RE: AMENDING SITE PLAN (SP2018-027), YMCA Lighting Plan

Project Number: SP2018-027
Project Name: 1210 N. Goliad Street
Project Type: SITE PLAN
Applicant Name: RUDY BANUELOS
Owner Name: YMCA, OF DALLAS
Project Description:

Project Number SP2018-027	Owner YMCA, OF DALLAS	Applied 8/14/2018	LM
Project Name 1210 N. Goliad Street	Applicant RUDY BANUELOS	Approved	
Type SITE PLAN		Closed	
Subtype AMENDING		Expired	
Status Staff Review		Status	
 Site Address 1210 N GOLIAD		City, State Zip ROCKWALL, TX 75087	
		Zoning	
Subdivision CARUTH LAKE PH 1	Tract 1	Block A	Lot No 1
		Parcel No 4842-000A-0001-00-OR	General Plan

SUBJECT: SP2018-027; HER Chilton YMCA Rockwall – *Photometric Plan*

ELECTRICAL - PHOTOMETRICS PLAN

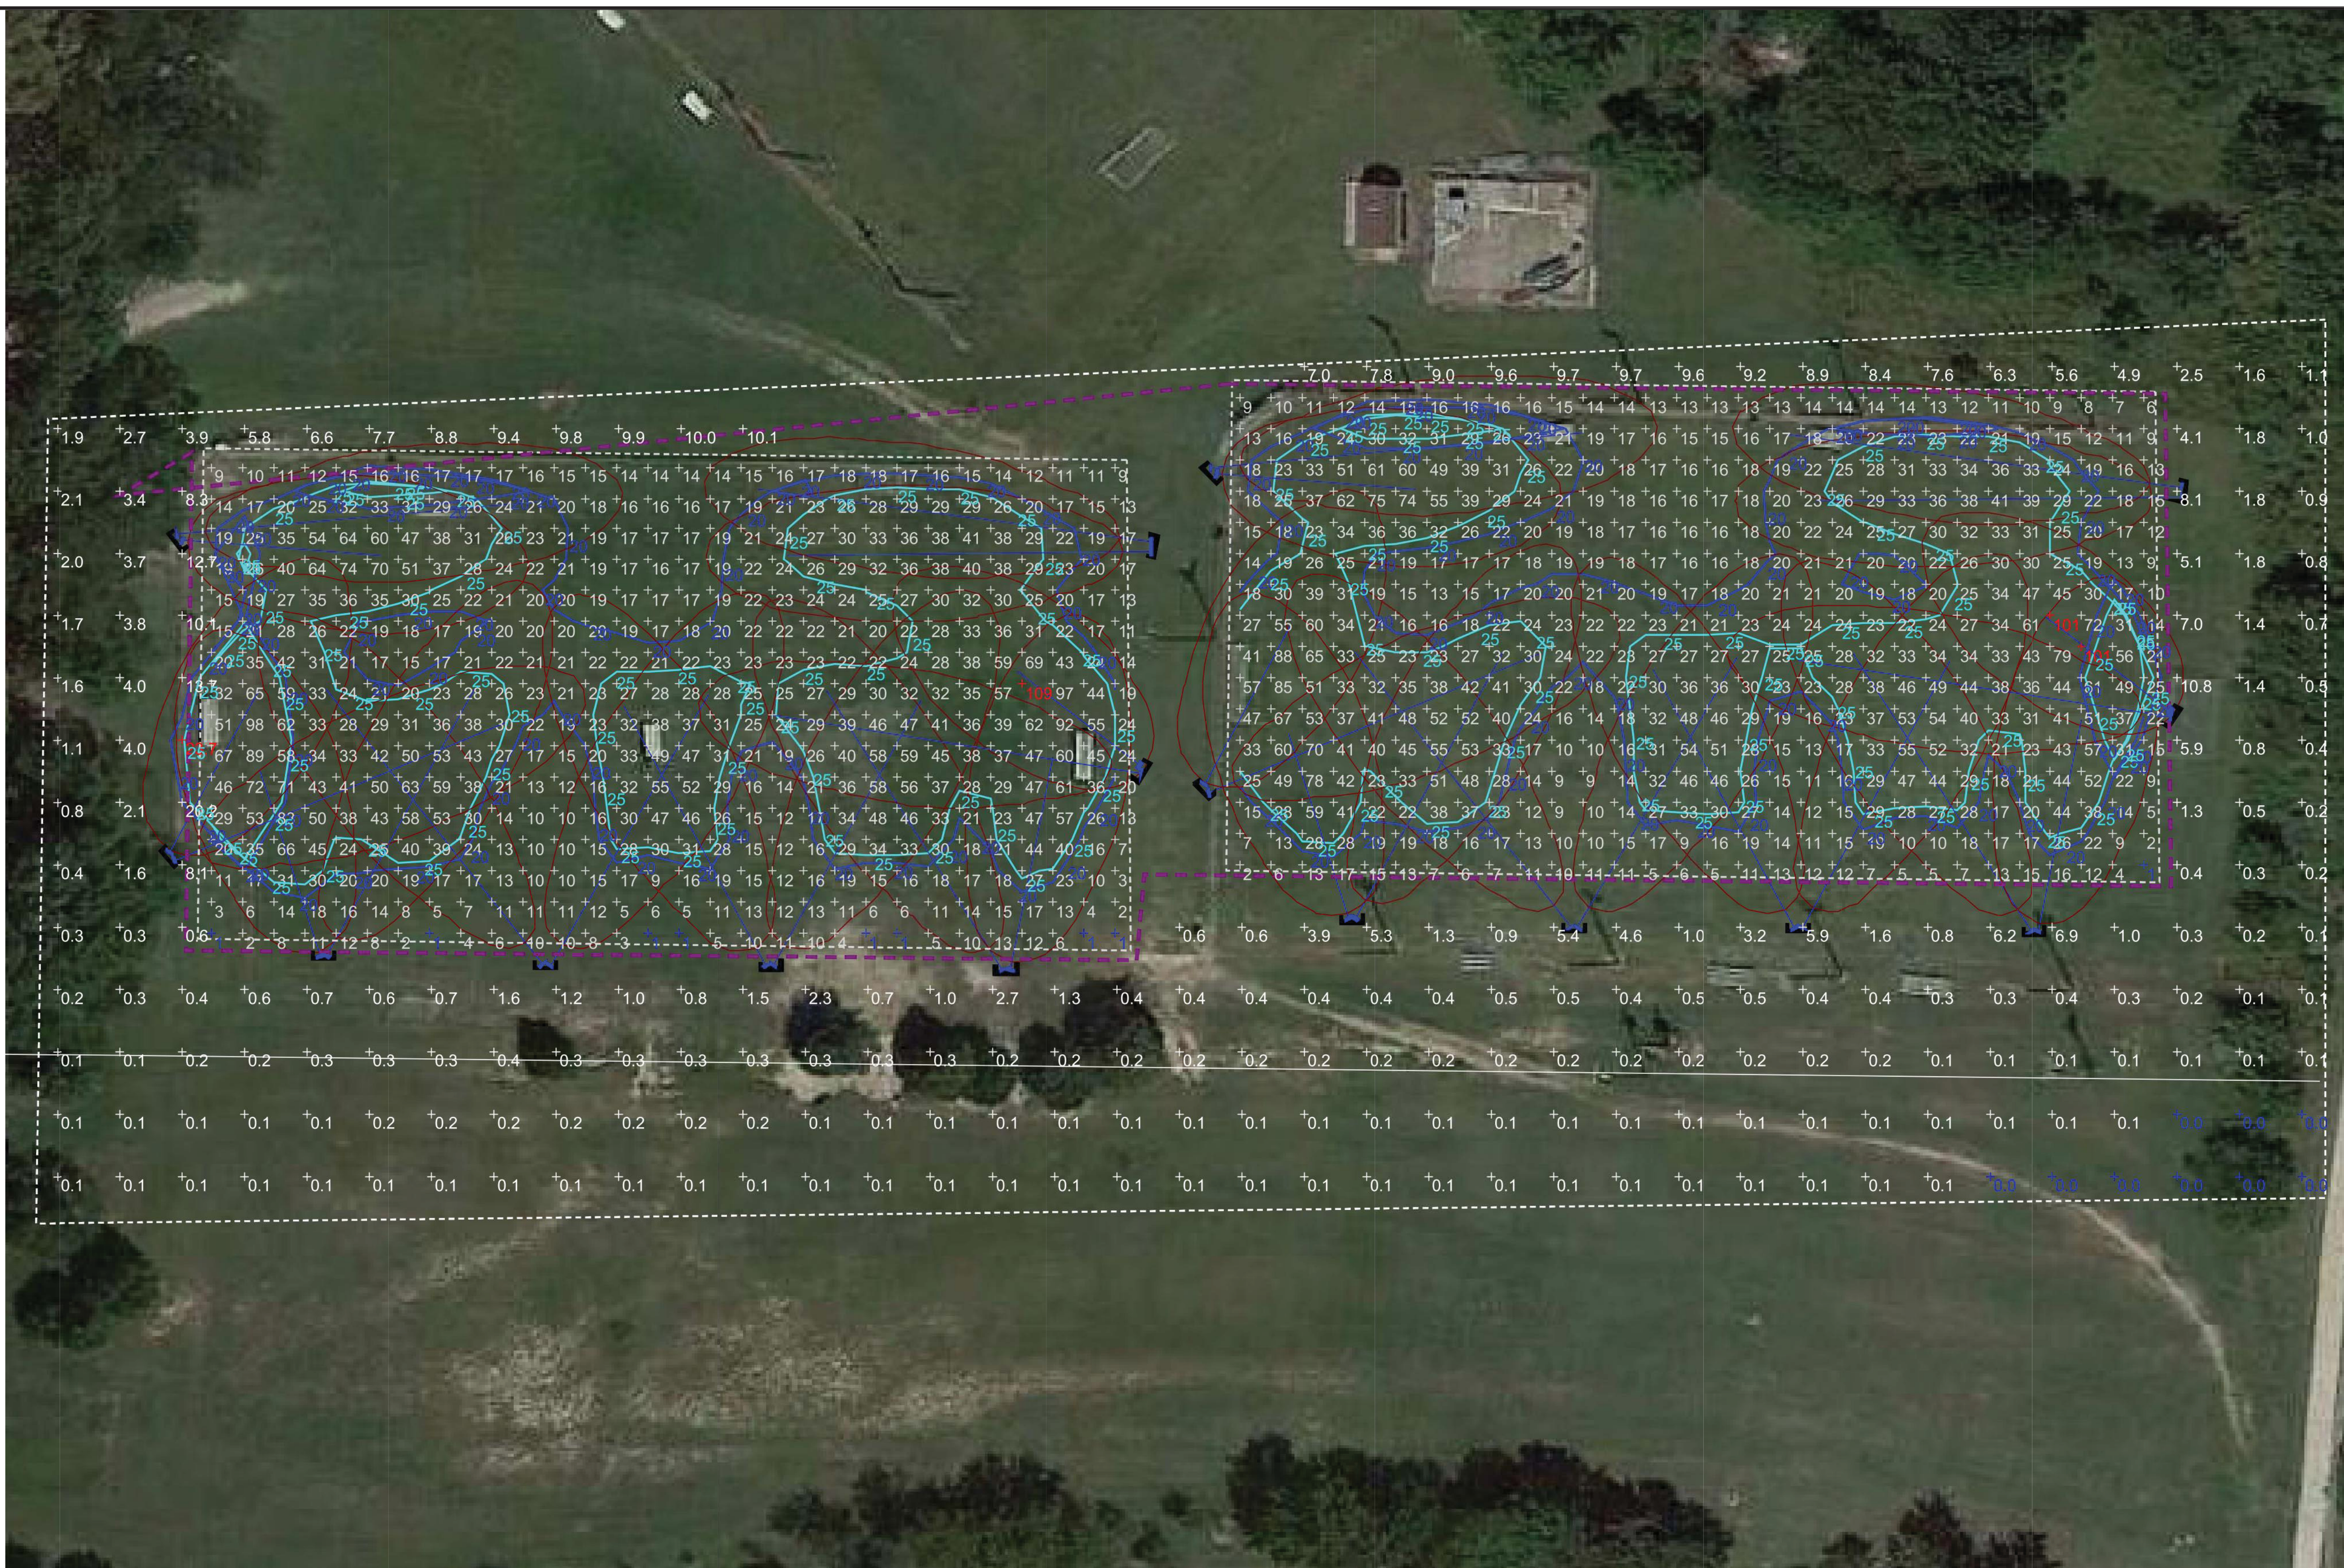
1. On all future submittals please include the Case Number (SP2018-027) on the lower right hand corner.
2. Sec. 3.3.C, of Art. VII Environmental Performance, of the UDC states: "Light at nonresidential property line. The allowable maximum light intensity measured at the property line of any nonresidentially zoned lot shall be 0.2 of one footcandle." The lighting levels for the westerly located ball field do not meet this standard by exceeding 0.2-FC at the southern property boundary.

3. Sec. 3.3.D, of Art. VII Environmental Performance, of the UDC states: Height. No light pole, base or combination thereof shall exceed 30 feet, unless further restricted within an Overlay District as specified in article V of this [Unified Development] Code." The North SH-205 Overlay (N SH-205 OV) District requires outdoor lighting pole, base or combination thereof to not exceed 20 ft in overall height. Also, all lighting fixtures are to focus light downward and to be contained on the site.

NOTE:
BLINDERS/BLOCKERS REQUIRED ON SOUTH FACING
LIGHT POLES TO LIMIT FC LEVEL AT THE SOUTH
PROPERTY LINE. SUBJECT TO CITY APPROVAL

**11210 N. GOLIAD
YMCA ROCKWALL**

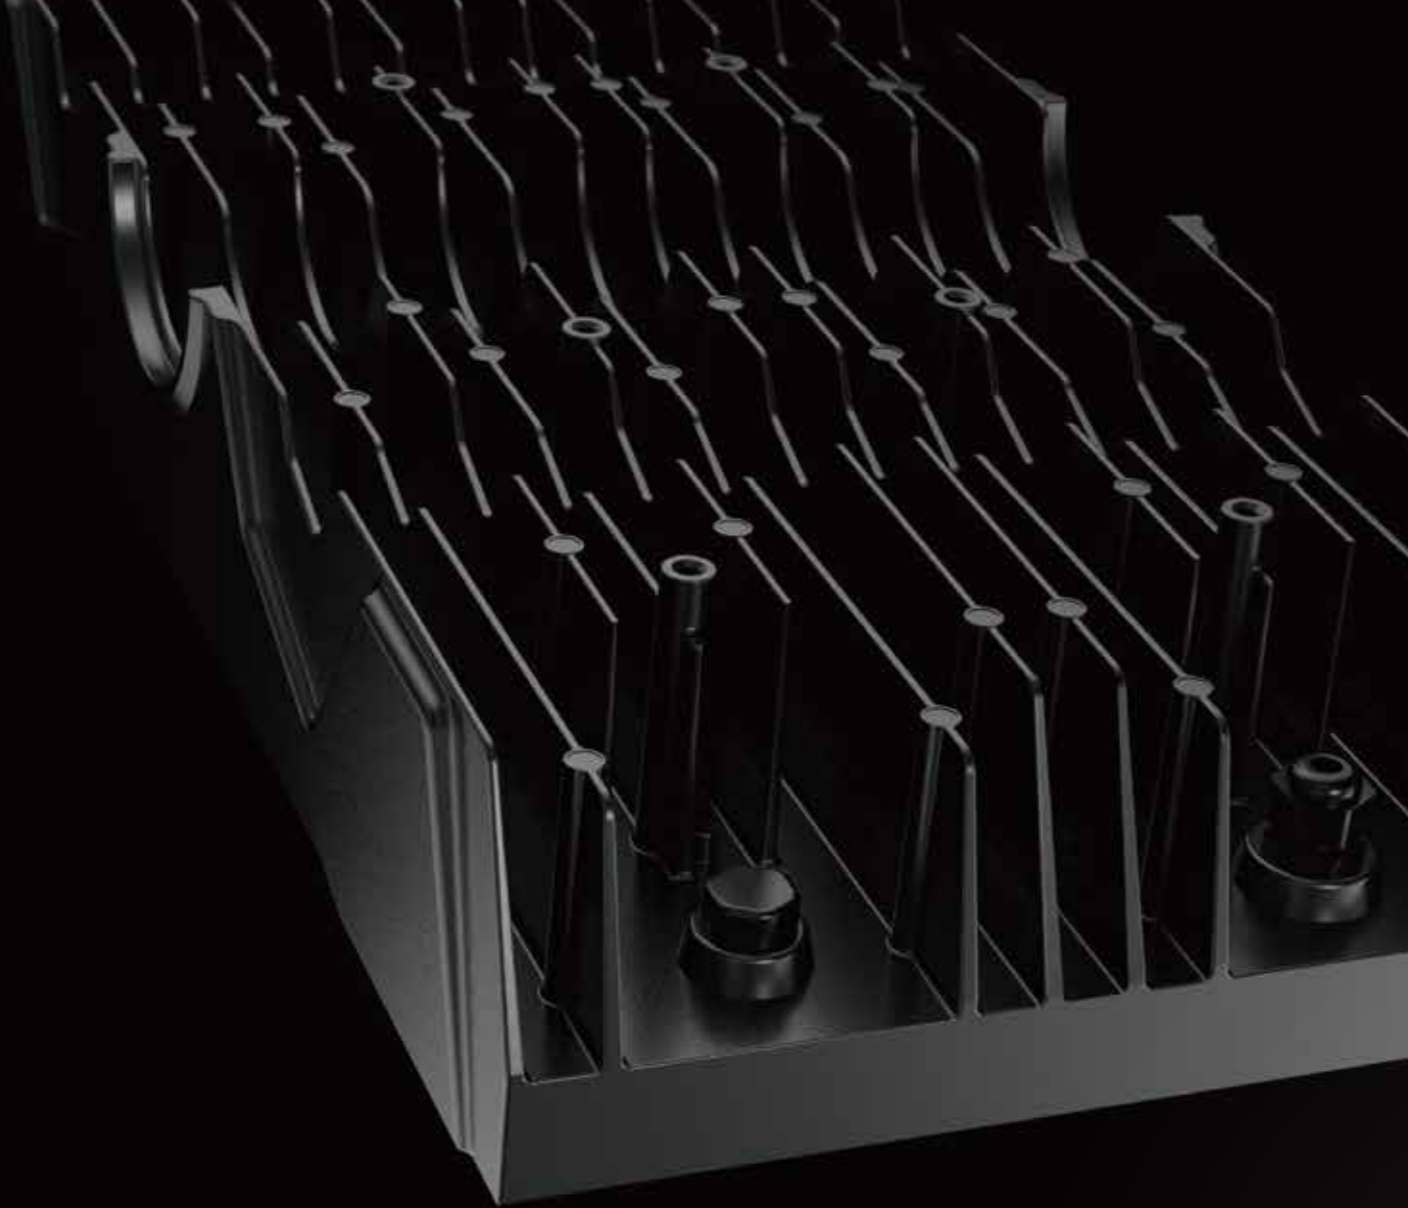
2. Sec. 3.3.G, of Art. VII Environmental Performance, of the UDC states: The maximum outdoor maintained, computed and measured illumination level within any nonresidential development shall not exceed 20 FC outdoors at any point on the site, with the following exceptions: 1. Under-canopy lighting (e.g., fuel stations, drive-through lanes and covered parking structures) shall not exceed 35 FC. The remainder of the property shall comply with the 20-FC maximum. 2. Lighting for motor vehicle dealerships shall not exceed 30 FC within the front yard(s) of the development. The remainder of the property shall comply with the 20-FC maximum. -- The lighting levels for the ball fields exceed the 20-FC candle limitation. The photometric plan indicates the maximum reading established for this area is calculated at 49.6-FC.

The new illumination, per photometric study provided, will be provided by replacing the thirty-six (36) old fixtures on one field with thirtytwo (32) new LED light fixtures spread over two fields. The light output of each LED fixture is approximately 72,000 Lm, total Lm for the new design 2,304,000 Lm, by simple math, each field will have approximately 1,152,000 Lm. The LED lighting is an efficient means to control the lighting with no spillage or overspill.

The photometric study rendering is completely flat and does not provide any simulation to the natural barriers to the North, South, East, or West sides of the soccer fields. The design calls for all fixtures to point away from the immediate neighborhood to the south side of the property.
